**Flood Control Project Maintenance  
Levee Inspections****LMA District Cover Sheet****Spring 2014 Levee Inspection Results****Sacramento Maintenance Yard East Levee Yolo Bypass**

**Levee Inspection Report By Mile - Spring 2014**

**Sacramento Maintenance Yard East Levee Yolo Bypass**

Photo 1 of 1 : johngw\_s\_20140317\_633.jpg

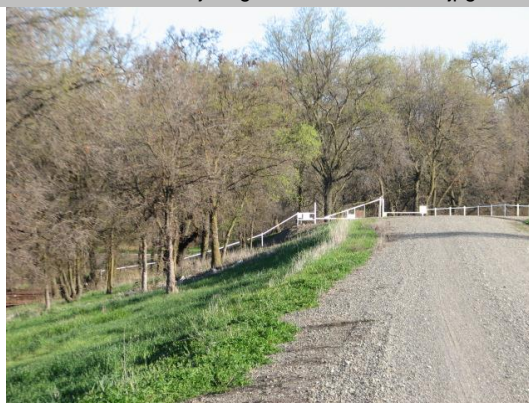
LM Start	0.01	Rating **	A/W	Issue No.	11
LM End	0.19	Issue Type +	Ma	Location *	WS
Category	Earthen Levee			GPS Latitude/Longitude	
				Start	End
Item	Vegetation			38.765295 °	38.762751 °
				-121.635085 °	-121.635422 °
DWR ID	DWR_ST0004_01_f _ 2013_11				
Action/Comments					
Trees / Woody Vegetation

The trees at Fremont Weir need to be monitored for future removal if necessary. Spring 2014
